5. Masterplan Massing, Scale & Layout

5.1. Masterplan Evolution

MASTERPLAN MASSING, SCALE & LAYOUT

JUNE 2021 MASTERPLAN

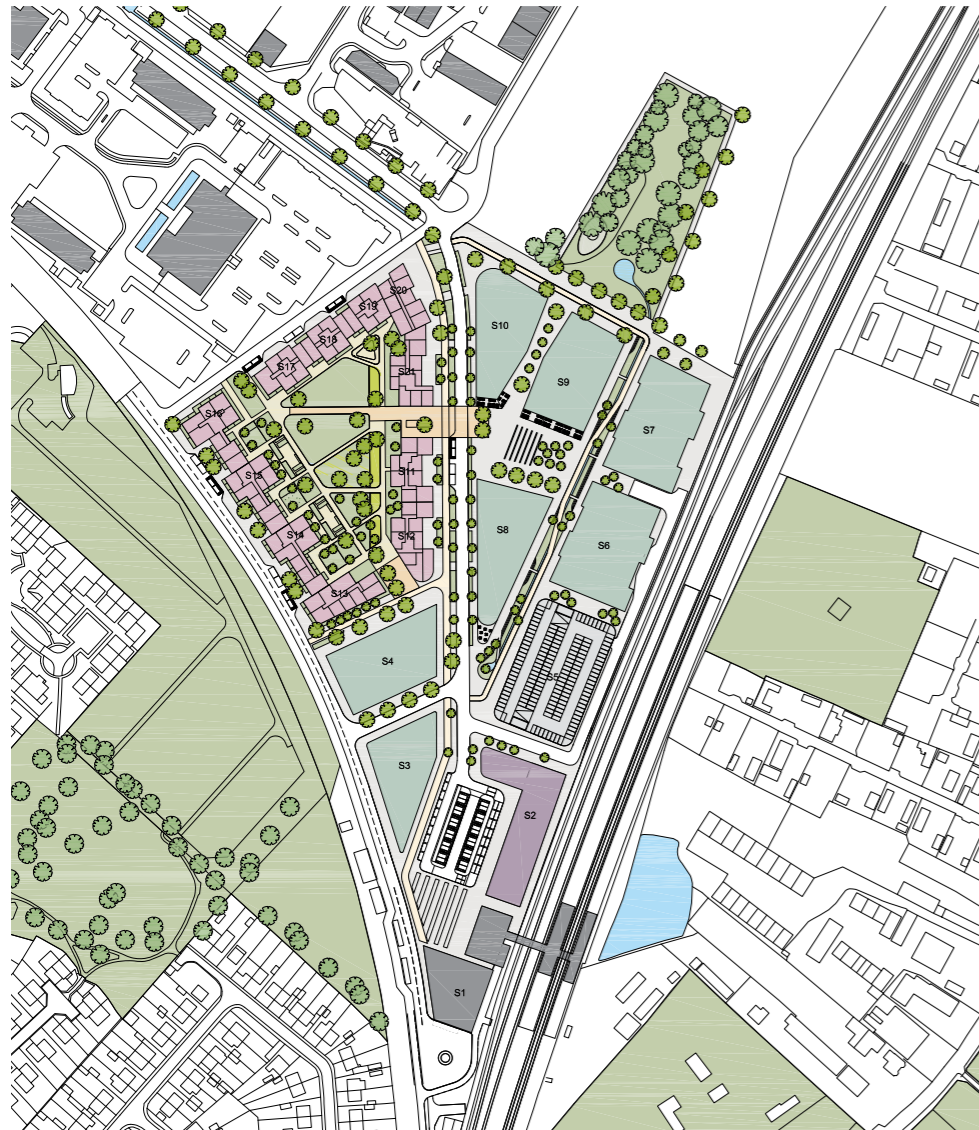
- (-) Proposed heights diagram (...) is misleading (...) the max height of 6 storeys is for exceptional elements (...) rather than a general acceptable height

- (-) All areas on the western side of the site adjacent to the allotment and nature reserve are suitable for up to 5-6 stories (...) a good proportion of the buildings range from 5-6 storeys, but too many max out at 8.

- (-) The tower block, S20, office block S4 and the buildings along the eastern edge raised serious concerns (...) all in all, it is considered the scheme may work better without the addition of a tall tower.

- (-) S17-S19 appear too monolithic. These blocks are unacceptable in their present form. Further articulation is required.

- (+) The aspirations of the team to actively target / attract independent stores is also welcomed.
- (-) Will there be enough demand for these spaces as envisaged bearing in mind we would have to consider the application on its merits

- (-) Will the success of business in this area undermine what could be delivered in the rest of the AAP area, if this were to come forward as envisaged?

- (+) Introduction of duplex apartments on the ground floors with front doors on the street and bedrooms on first floor level are supported.
- (-) Could a more central/convenient location for the supermarket be considered?

- (+) Diagram has been amended to reflect more accurate depiction of heights.
- (+) All buildings on the western edge of the resi has been adjust in line with draft NEC AAP draft with maximum height capped at 6 storeys.

- (+) Tower block has been reduced to 8 storeys in line with draft NEC AAP.
- (+) Principle has been adopted and retained in the latest masterplan design proposal.

- (+) Layout of buildings have been adjusted to create more stepping and articulation.
- (+) Principle has been adopted and retained in the latest masterplan proposal.

- (+) Principle has been adopted and retained in the latest masterplan proposal.
- (+) Principle has been adopted and retained in the latest masterplan proposal.

- (+) Ground activation strategy now takes into consideration class E allocated space to allow the scheme flexibility to adapt to changing demands.
- (+) Principle has been adopted and retained in the latest masterplan design proposal.

JUNE 2021 MASTERPLAN

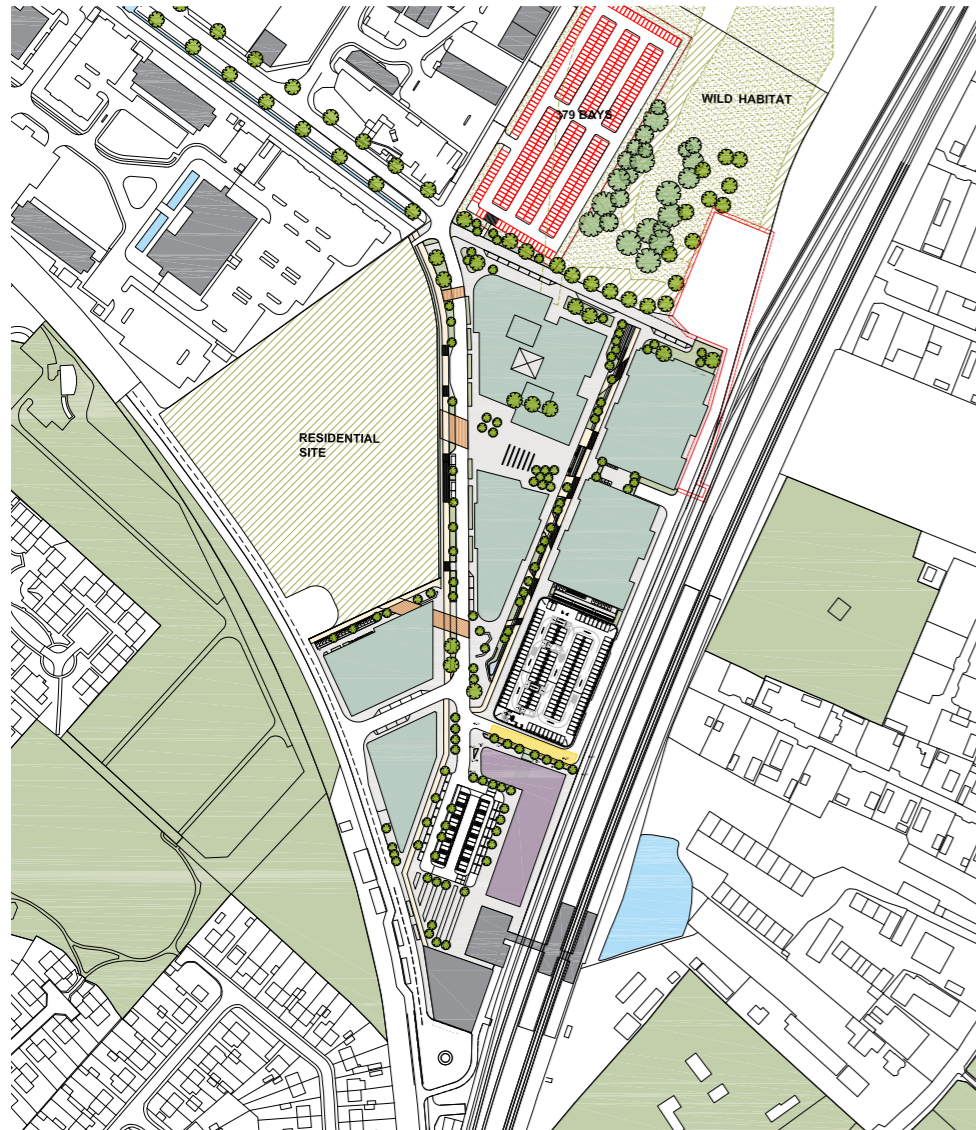
- (+) Play has been considered at some level within the proposals for the BTR area which is welcomed. The calculations submitted are in accordance with the local plan policy
- (-)The provision for formal children's play is one quarter the size it should be. A population profile should be provided to seek to justify the under provision.
- (-) Although there is no policy requirement for open space for the commercial development, it does require open space(...) and this should not be counted as contributing to residential open space.(...) A quantification of the contribution of rooftop open spaces and roof top allotment space would be welcome
- (-)There is no space within the site for children or adults alike to kick a ball for instance.
- (-)Overlaying of drainage and landscape proposals need to begin to ensure that delivery is feasible with trees and more

- (+) Principle has been adopted and retained in latest masterplan design proposal.
- (+) Revised calculations presented reflecting compliance and removal of open space surrounding commercial plots. Rooftop open space provision calculations presented.
- (+) Central park adapted to allow for open space for such informal play.
- (+) Attenuation study presented to show placement of attenuation crates and SUDs, and non conflict with proposed trees.

NOVEMBER 2021 MASTERPLAN

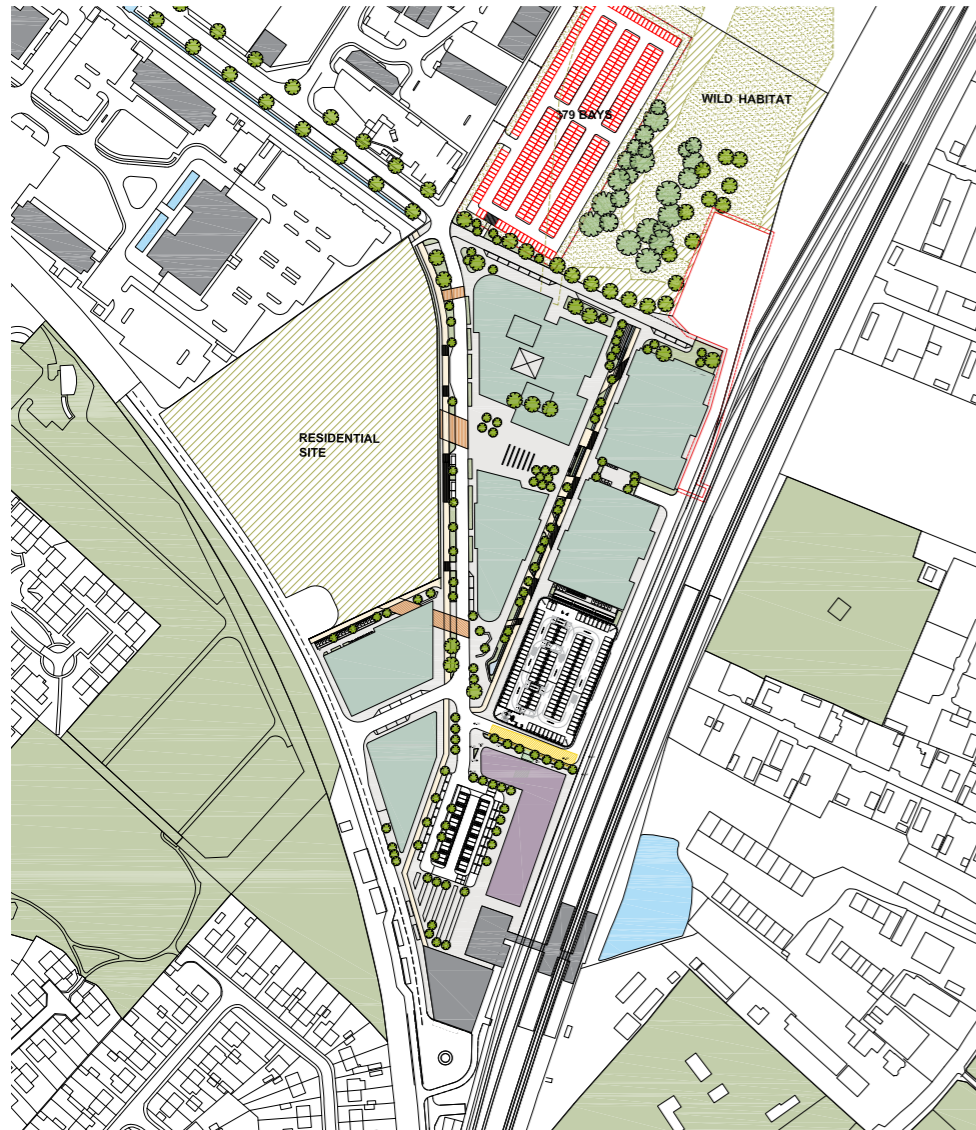
(-) We are due to have a workshop with the county later this month where we need to understand what measures are proposed to ensure the trip budget is not exceeded.

- (-) Will there be sufficient demand for these spaces to become occupied?
- (-) Will the success of businesses in the area undermine what could be delivered in the rest of the AAP area.
- (-) Units at ground level of the car park are supported in principle. But will there be enough of the right type of occupiers that can be accommodated.

- (+) A section through Swale street between S7 and S9 with various options (...) has been provided (...) is considered acceptable in this location.
- (-) It needs to be demonstrated that the trees can thrive in this location.
- (-) There is concern about the cantilevered, perforated metal decking (...) not supported for reasons of maintenance, rubbish and weeds accumulation.

(+) Trip budget has been discussed with county pending confirmation from the local planners.

(+) Class E allocation will allow flexibility to suit demand.

(+) Sections through swale provided to show adequate soil depth.

(+) Cantilevered decking replaced with solid cycle path with attenuation crate below.

NOVEMBER 2021 MASTERPLAN

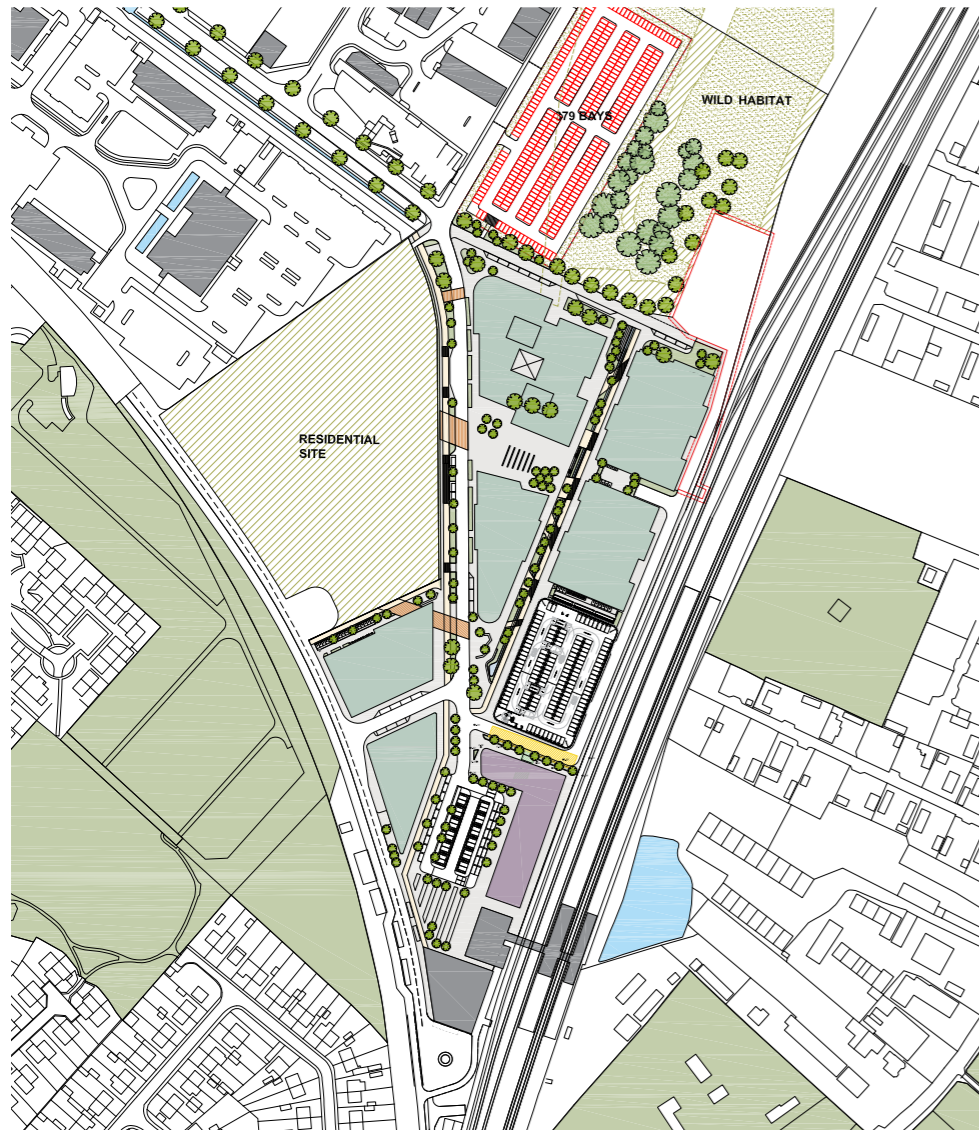
- (+) The overall street width varies from 25-31m with buildings 20m to 30m on either side. This provides a high level of enclosure, creating an urban character which is considered appropriate in this location.
- (+) Introduction of occasional street trees , together with a change in vertical alignment and surface materials (...) is supported.
- (-) Widening the cycle way to 3.5-4m would help to future proof this important route.

- (+) Current proposal is to direct traffic from Milton avenue to the car park entrance to the east of the building via a street north of the hotel (...) we appreciate this is due to access requirements from Network Rail and present the best possible - and hopefully temporary- solution
- (-) A shared surface / pedestrian priority design would be desirable on urban design grounds.

- (+) The changes of the ground floor footprint of 1 Milton Avenue to ease views and movement between the residential development and the station is supported .
- (-) This could put a number of potential cycle movements through the residential garden area. Is this to be encourage?

- (+) This view shown on Slide 50 looks rather bleak the street requires further landscaping and/or more articulation.

(+) Principle has been adopted and retained in the latest masterplan proposal.

(+) Principle has been adopted and retained in the latest masterplan design proposal.

(+) Principle has been adopted and retained in the latest masterplan proposal.

(+) Shared surface design adopted and implemented by landscape architect.

(+) Principle has been adopted and retained in the latest masterplan proposal.

(+) Residential scheme has been moved to a separate application to streamline the application of the commercial site.

(+) Principle has been adopted and retained in the latest masterplan proposal.

(+) Principle has been adopted and retained in the latest masterplan proposal
